ADMINISTRATIVE FINAL
ENVIRONMENTAL IMPACT REPORT

SALINAS UNION HIGH SCHOOL DISTRICT NEW MIDDLE SCHOOL #5 CONSTRUCTION

SCH# 2015081022

November 10, 2016

Figure 6
Proposed Central Area Specific Plan
SUHSD New Middle School #5 Construction EIR

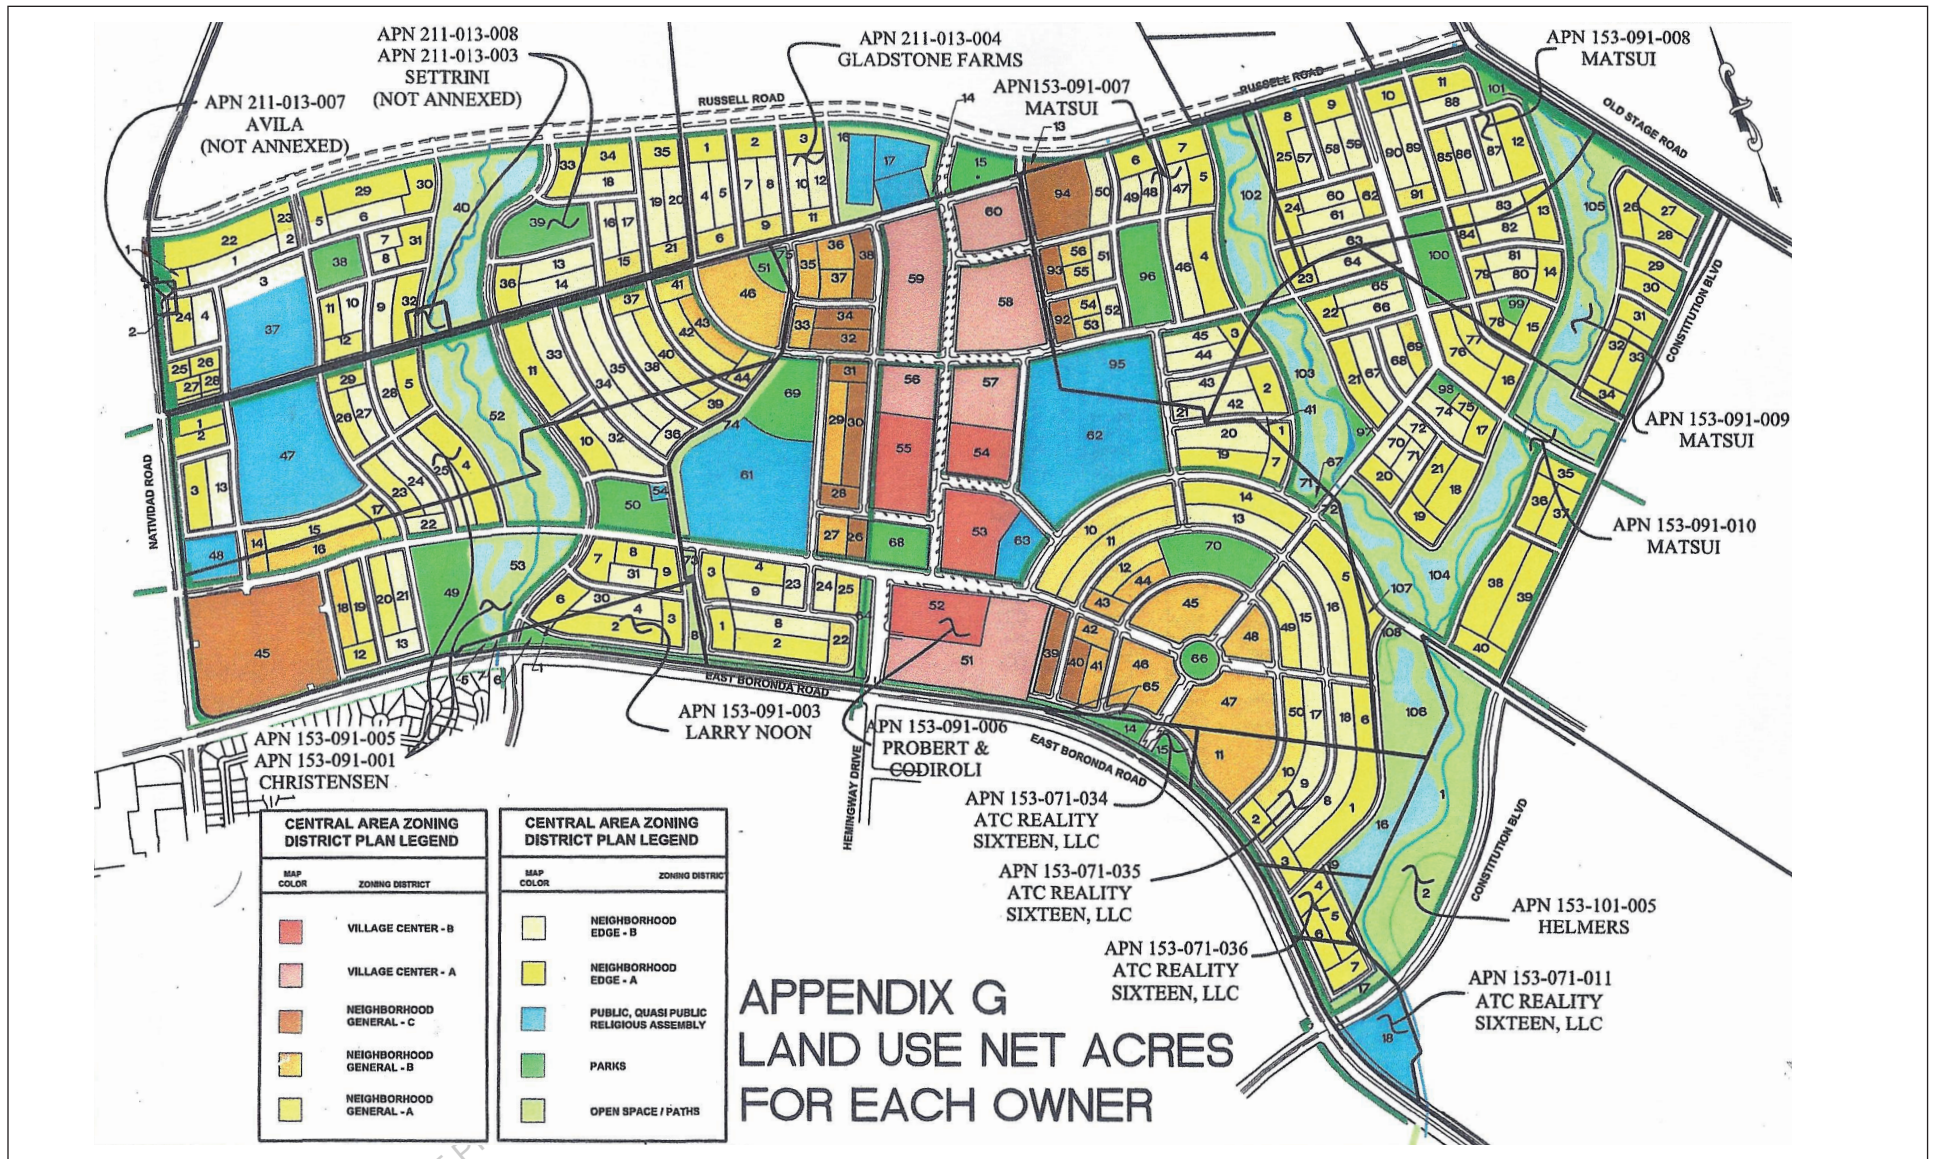
5. Figure 6 roadway configuration of Hemingway Drive extension does not coincide with Figure 9.

15. The comment does not raise an environmental issue and therefore, no response is required.
16. See response number three above. Figure 6, Proposed Central Area Specific Plan, is amended to reflect current design plans for the extension of Hemingway Drive, as displayed in Section 3.0 Changes to the Draft EIR.

Figure 6, Proposed Central Area Specific Plan included in the Draft EIR has been replaced with the following [Figure 6, Proposed Central Area Specific Plan](#), presented below.
